SUBJECT APPROVED REVISED PROJECT CONCEPT REPORT

SUBJECT **Revised Project Concept Report**

Revised Concept Report

STP-159-1(14)
SR 41 under CSX Railroad
Meriwether County
P.I. No. 321880

ATTACHMENT "B"

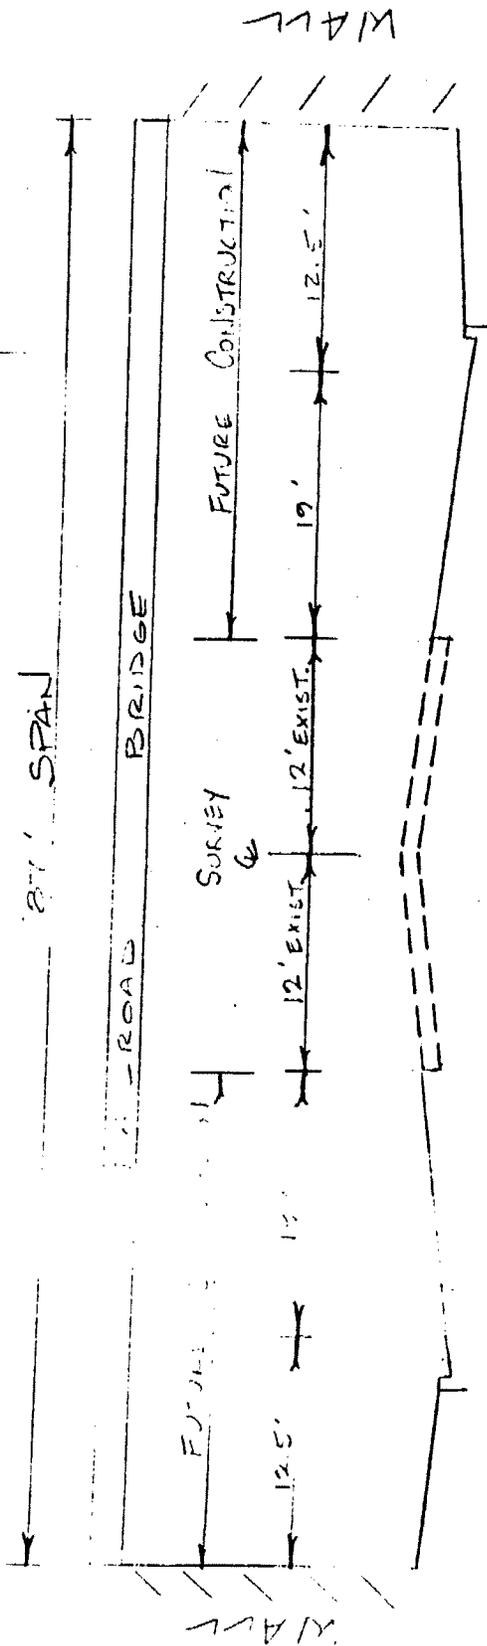
2 way detour?
need retaining walls end-bents?
close rd for removing old bridge?
use state rd detour?
what will grade be south
of new bridge?
